U.S. NUCLEAR REGULATORY COMMISSION

OFFICE OF NUCLEAR REGULATORY RESEARCH
(DG)-5061

Proposed Revision 1 to Regulatory Guide 5.71

CYBER SECURITY PROGRAMS FOR NUCLEAR FACILITIES POWER REACTORS

Figure 1 - Security ~~life cycle process~~ Life Cycle Process

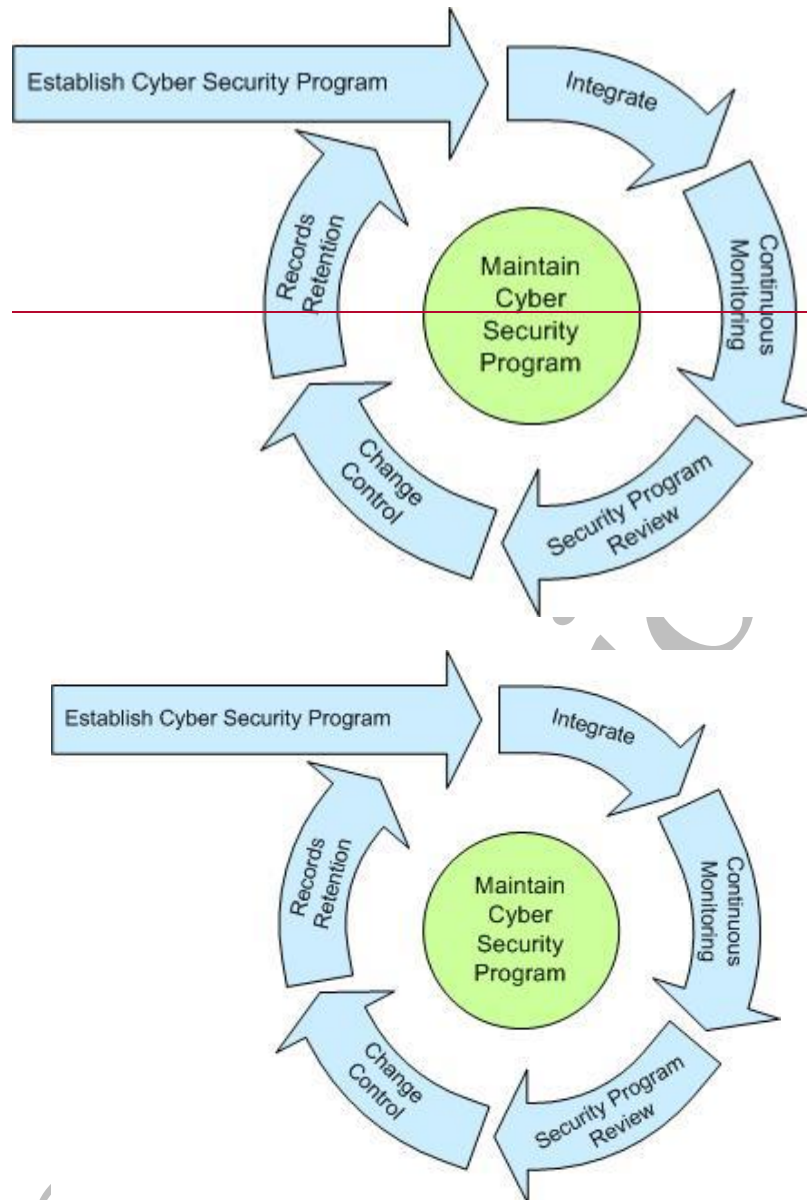
~~An~~As described in an acceptable method to establish a cyber security program at a facility is by performing the following: ~~(1) analyze the digital computer and communication systems and networks, (2) perform a review of the CDAs in Section C.3.1.4, (3) deploy defensive architecture described in Section C.3.2.1, (4) address potential cyber risks to CDAs as described in Section C.3.3, and (5) implement the security life cycle activities discussed in Section C.4 to maintain the cyber security program.~~

Figure 2 -Categorization of ~~plant systems~~Plant Systems

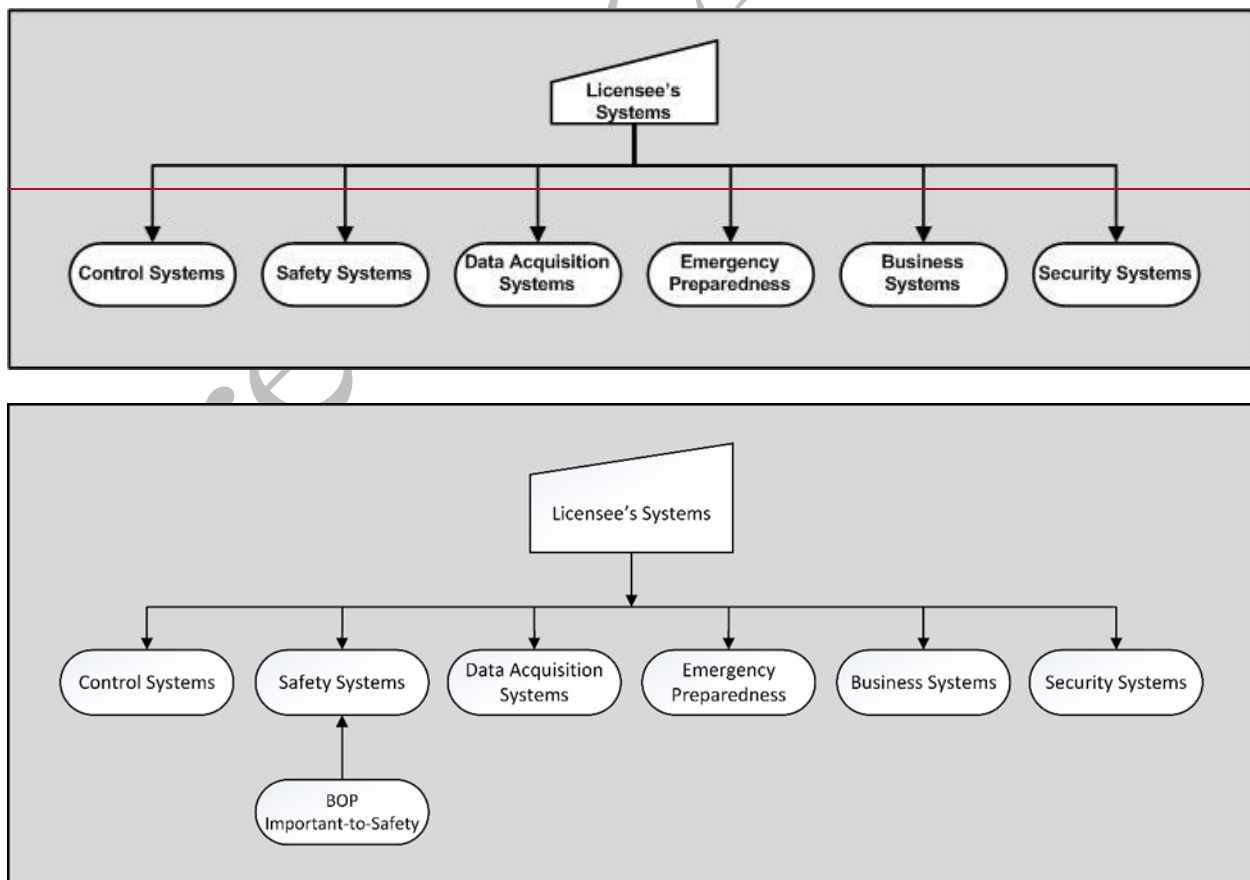
To identify CDAs, a licensee should first identify the overall allocation and organization of plant systems, equipment, communication systems, and networks that are associated with the SSEP functions or support systems that are associated with SSEP functions. ~~-These systems, hereafter broadly referred to as “critical systems” (CSs), may or may not be digitally controlled, and therefore, may or may not ultimately be within the scope of the licensee’s cyber security program.-~~ The licensee should conduct an initial consequence analysis of plant systems, equipment, communication systems, and networks to determine those which, if compromised, exploited, or failed, could impact the SSEP functions of the nuclear facility. ~~-This analysis should be conducted without accounting for existing mitigating measures to determine what the “worst case” impact would be if the CDA were to be compromised.~~

Figure 3 -Evaluation process for determining critical systems
Process for Determining Critical Systems
With the

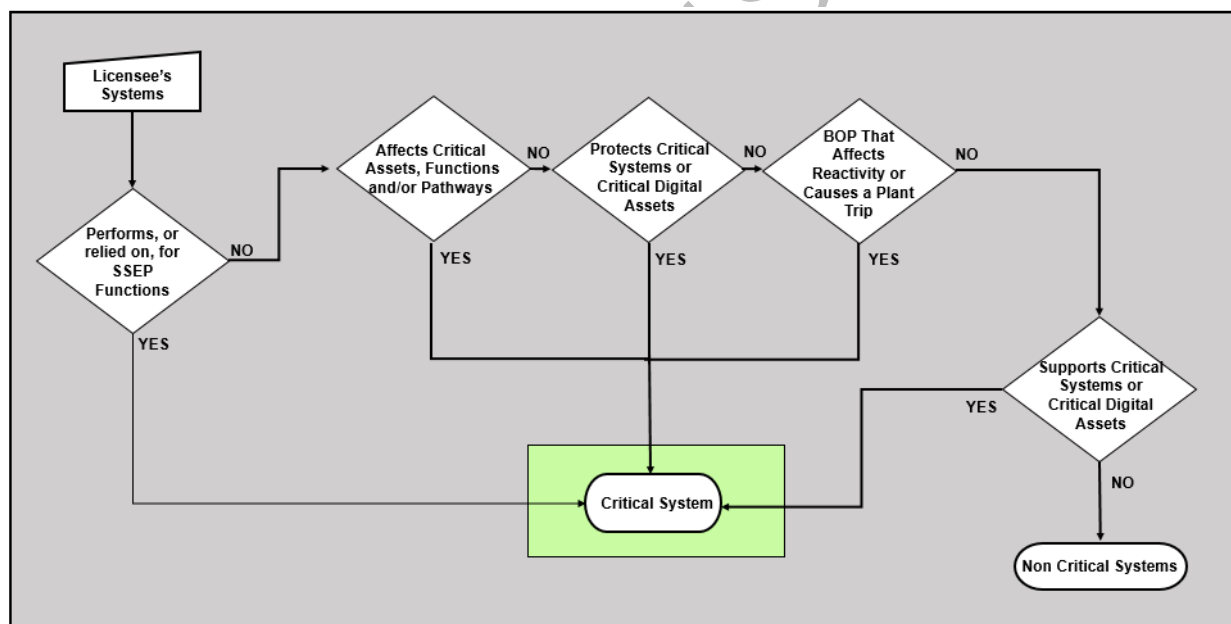
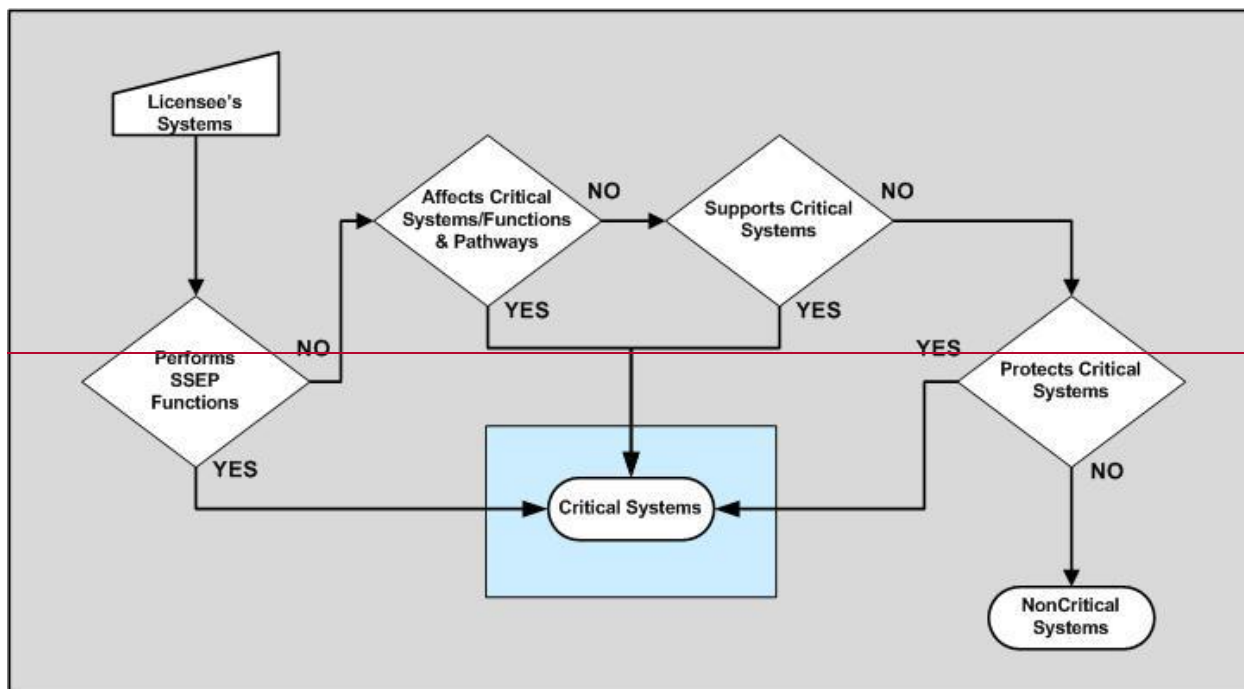
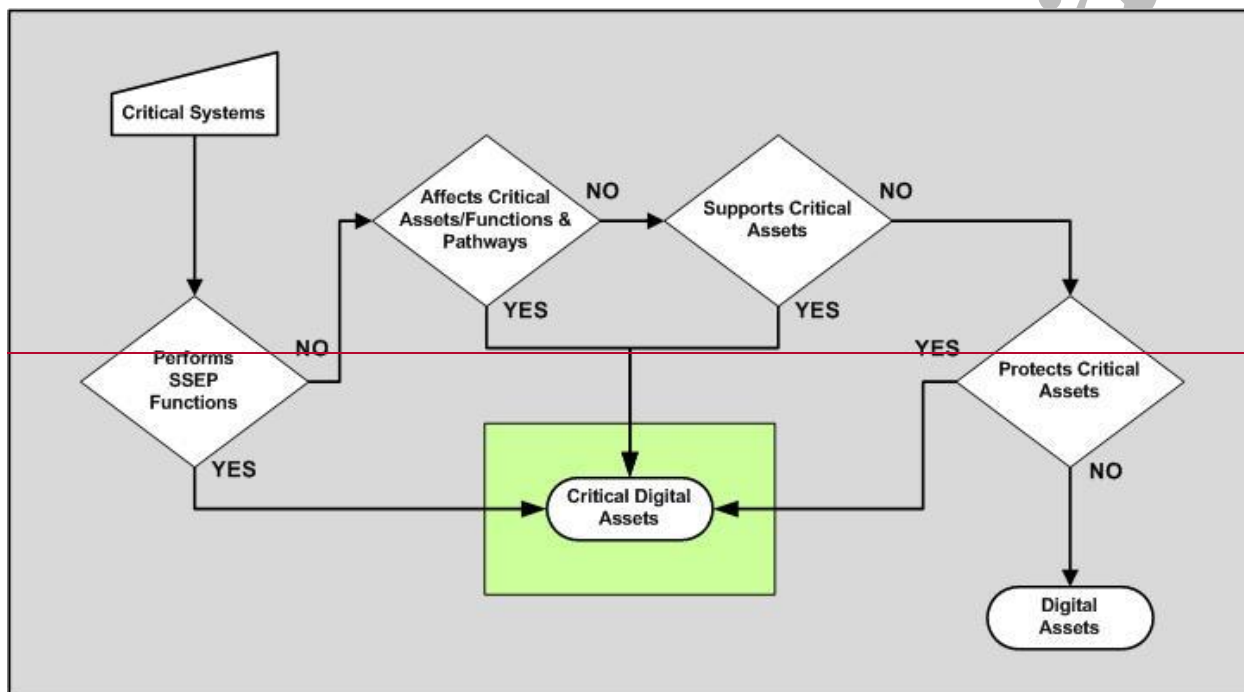
Following identification of ~~the all the~~ CSs, the licensee should ~~then~~ analyze and identify which specific assets are actually CDAs, and thus within the scope of 10 CFR 73.54. -A CDA may be a component of a CS, may protect a CS from cyber attack, or may be directly or indirectly connected to a CS. -The direct connections may include a wired or wireless pathway (involving a chain of connections). The indirect connections may include “air-gapped” systems, CDAs behind a one-way security boundary device, or “sneaker nets” by which data or software is manually carried from one digital device to another and transferred using physically transportable storage medium, such as floppy disks, thumb drives,

Figure 5 -Simplified ~~cyber security defensive architecture~~Cyber Security Defensive Architecture

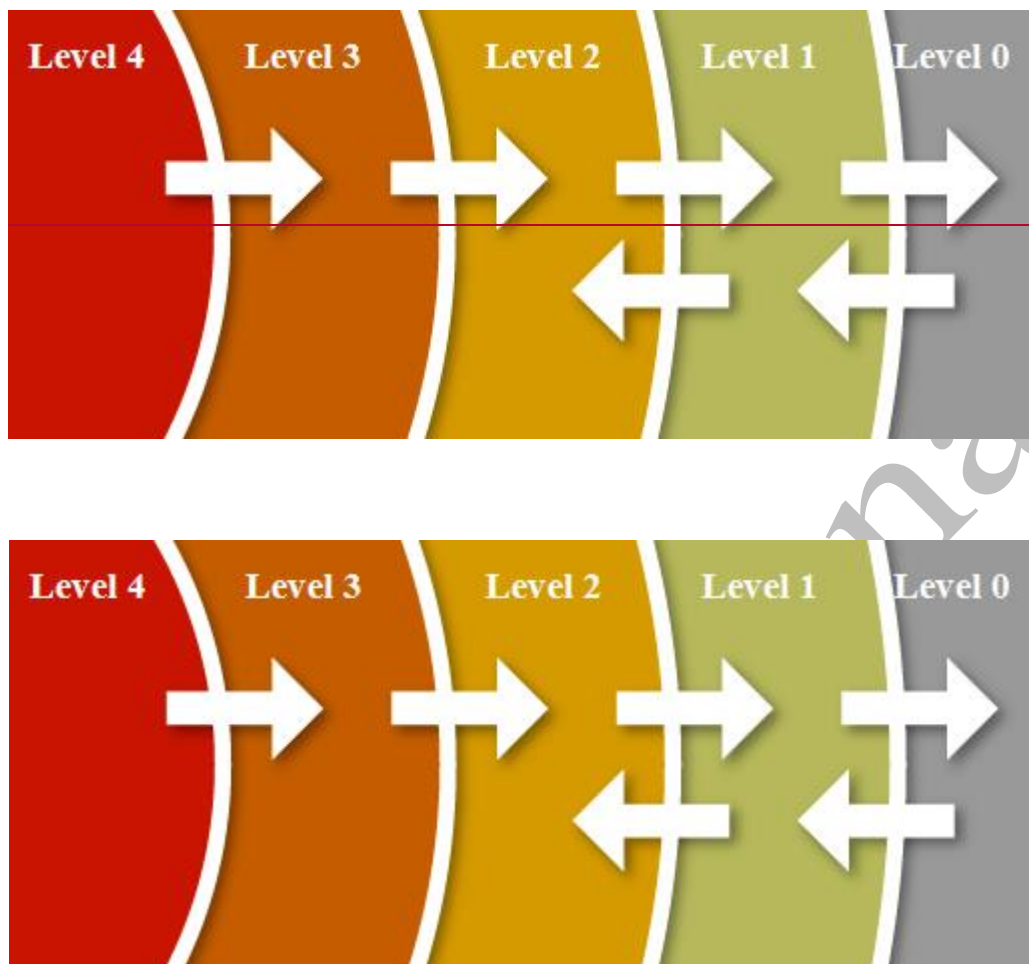
Figure 5 provides an example of an acceptable cyber security defensive architecture. -This defensive architecture includes five concentric cyber security defensive levels separated by security boundaries, such as firewalls and diodes, at which digital communications are monitored and restricted. Systems requiring the greatest degree of security are located within ~~a greater number of boundaries.~~ ~~the~~ ~~most secure level of the defensive architecture.~~ The logical model shown below does not always correspond directly with the physical locations such as the vital, protected, or owner-controlled areas.
